# Game Manual - Team UPDATE - 1358294763

Figure 3-5a: ROBOT inside 54 in. diameter cylinder

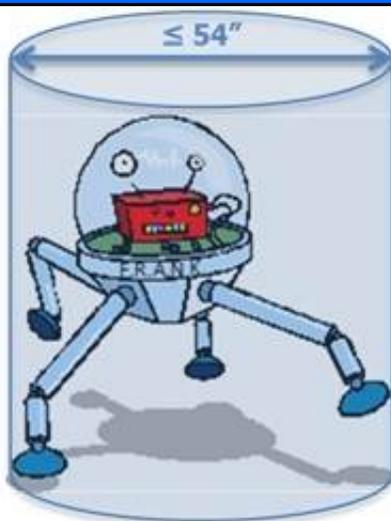
While not in contact with the PYRAMID, a ROBOT'S horizontal dimensions may never exceed a 54 in. diameter vertical cylinder.

In other words, a ROBOT must always fit inside a cylinder with a diameter of 54 in. This method for restricting ROBOT size requires extra diligence if a ROBOT'S geometric center shifts as various appendages are extended and retracted.

Figure 3-5b: Offset Plane from PYRAMID Base

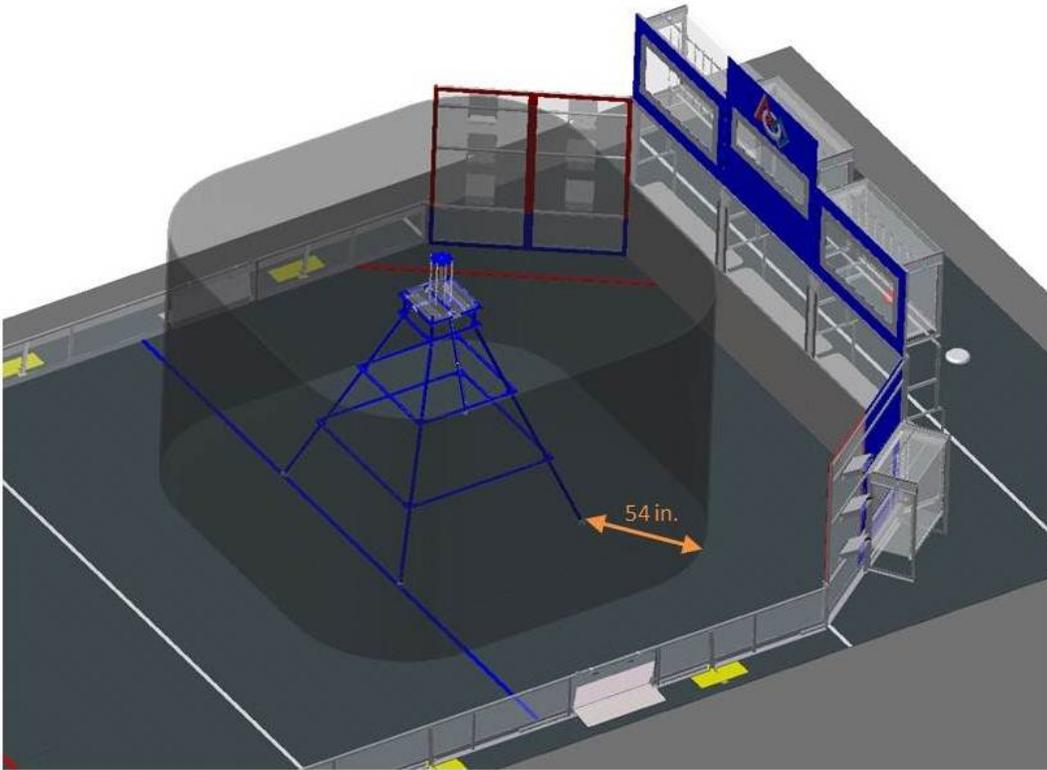
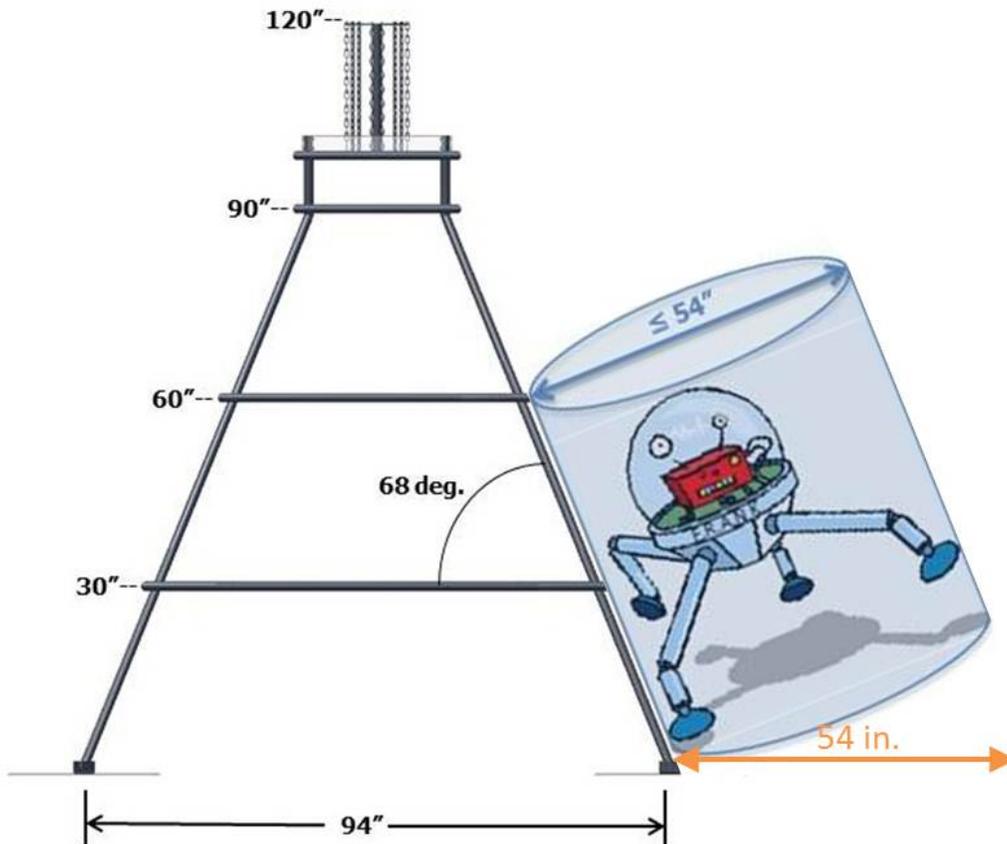
While in contact with the PYRAMID, a ROBOT

- A. may not have its horizontal dimensions exceed a 54 in. diameter vertical cylinder relative to the ROBOT and
- B. may not extend any part of itself beyond a vertical plane defined by a perimeter offset from the base of the PYRAMID by 54 in., see Figure 3-5b and Figure 3-5c.

Figure 4-2: BUMPER Corner Examples (UPDATED)

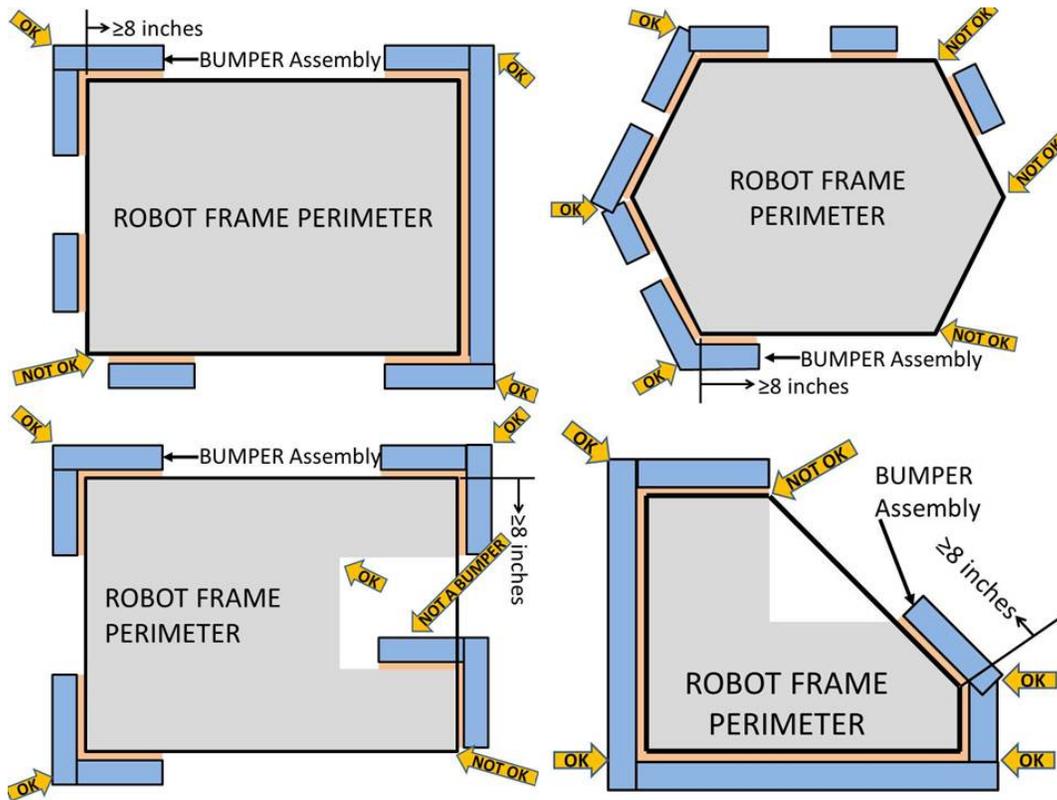
ROBOTS are required to use BUMPERS to protect all outside corners of the FRAME PERIMETER. For adequate protection, at least 8 in. of BUMPER must be placed on each side of each outside corner (see [Figure 4-2](#)).

The dimension defined in R22 is measured along the FRAME PERIMETER. The portion of the BUMPER that extends into the corner is not included in the 8 in. requirement.

Figure 2013-01-15

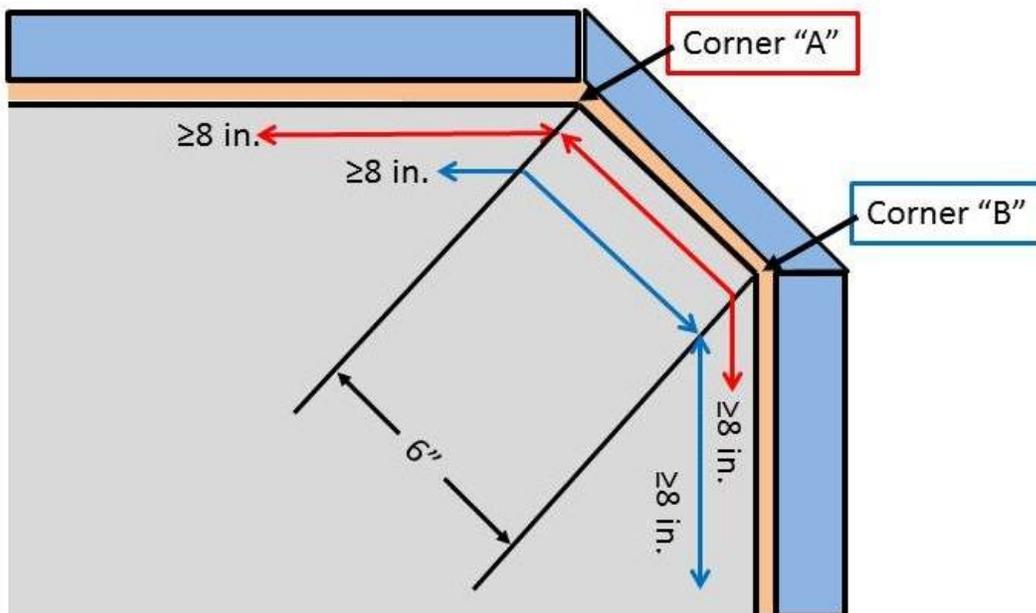
The Inspectors also asked for clarification on the 8 in. BUMPER requirement of R22. As stated in the Blue Box on R22, the dimension is measured along the FRAME PERIMETER. In Figure 2013-01-15 below, the edge of the FRAME PERIMETER between Corner A and Corner B is only 6 in. To satisfy the 8 in. requirement for Corner A, there must be at least 8 in. of BUMPER in each direction. Thus, the measurement along the 6 in. side would continue past Corner B for 2 more inches.
